Change Request

Number: 18
Date: 1/18/2018
Project: Wilco WCCHD Office Renovations
Job #: 6148E

Description: Mechanical for HVAC Changes

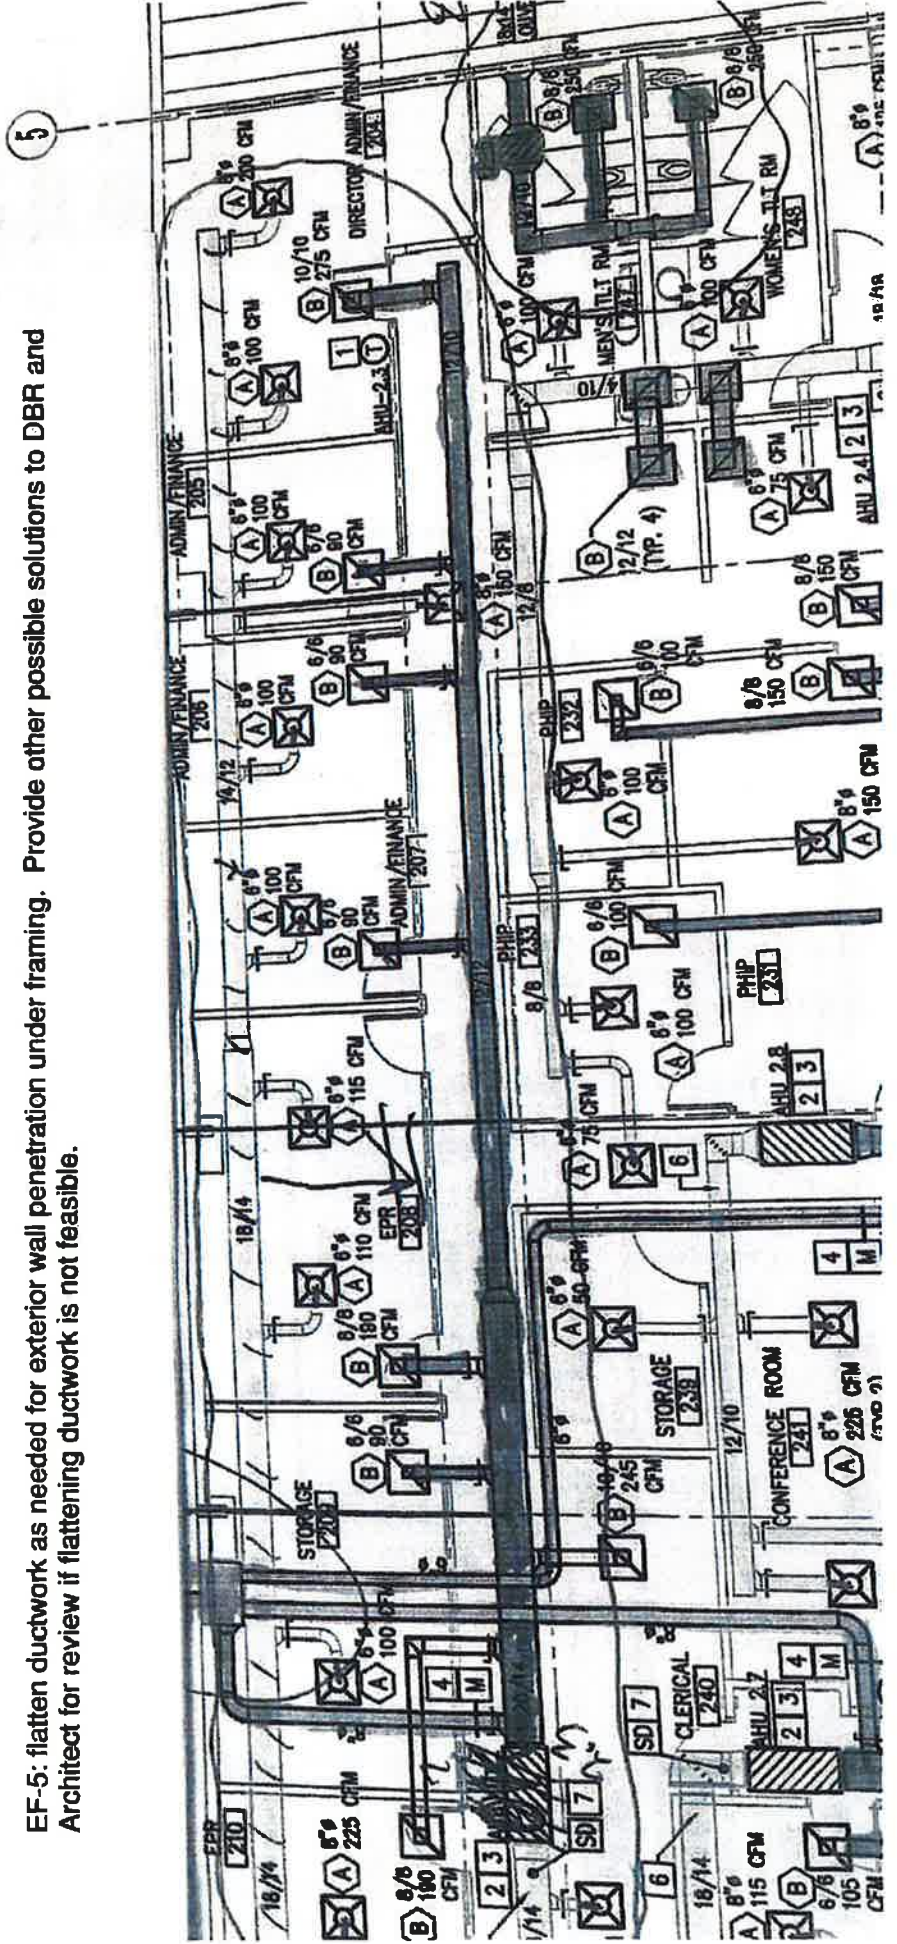
This is a follow up to RFI #13. Resolution for the HVAC conflicts for the second floor were not included in the RFI response.

These items were discussed with the architect on site on 9/29/17. The beams are too low to install the duct where shown on the plans. The engineer is also aware per the conversation we had in the meeting at Bob's office. The return air shown will also need to be relocated. These units are 2 1/2/2/2/3 plus exhaust. Marked up plans are attached.

Walked the building with Austin Young and reviewed the structural conflicts with proposed mechanical units on the 2nd floor and issues with the outside-air intake location.

- The existing main pre-engineered building structure conflicts with the proposed location of supply ductwork at the low-end of the roof eave (noted in RFI #20). Recommendation is to move the units and ductwork farther in from the edges of the building to allow for clearance. If required the ductwork can also be flattened per MEP response to RFI #20.

- The existing beam at the edge of the building conflicts with the proposed fresh-air intake vent and ductwork on the South side of the 2nd floor. Recommendation from review of this condition is to move this vent to the East wall in the adjacent room and take over an exhaust vent location that is not being re-used.

AHU-2.1: shift AHU-2.1 plan east for clearance away from beam. Provide supply air duct transition to get duct under beam (possibly 24/8). Shift supply duct up to middle of Rooms 219, 220, etc...until clear under beams. Provide duct transitions as required to get duct under beams.

AHU-2.2: Flatten supply air ductwork from AHU-2.2 (perhaps 30/8) for clearance under beam. If zero clearance is available under beam, shift AHU-2.2 and associated ductwork plan east. Western-most supply diffuser may need to shift plan east away from beam.

AHU-2.3: shift supply duct main from AHU-2.3 plan south until clear under beams. Provide transitions as needed and offset ductwork.

EF-5: flatten ductwork as needed for exterior wall penetration under framing. Provide other possible solutions to DBR and Architect for review if flattening ductwork is not feasible.
